То:	Howard Resnik, PE		
From:	Pat O'Mahony, Associate Planner; 910-341-0189		
CC:	File;		
Date:	12/17/2021		
Re:	Switchyard TRC Rev. 3

Project Name: **SWITCHYARD** Formal TRC #3 Date: **12.09.2021** Reviewer Name: **Mitesh Baxi** Reviewer Department/Division: **PDT/Traffic Engineering**

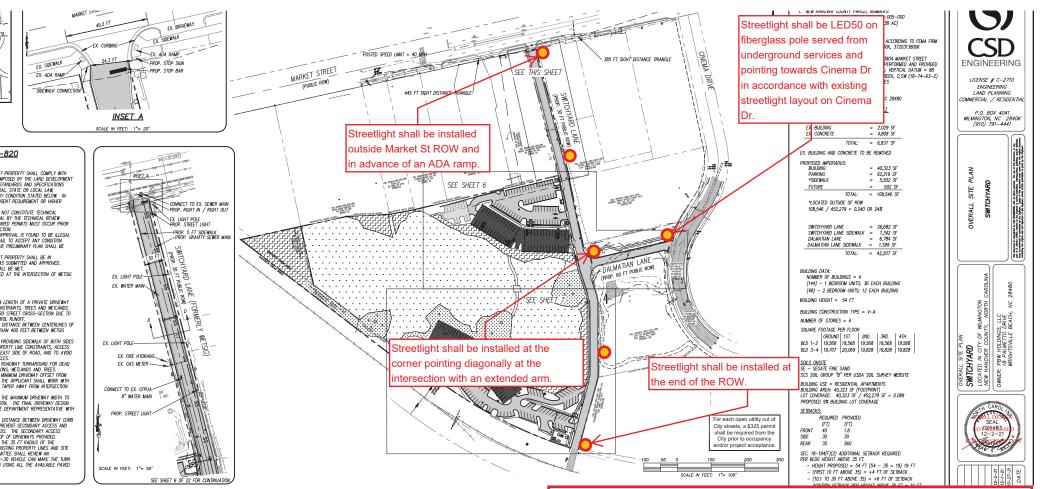
• Canopy trees required at the end of the parking rows shown below. Is the parking island 216sf?
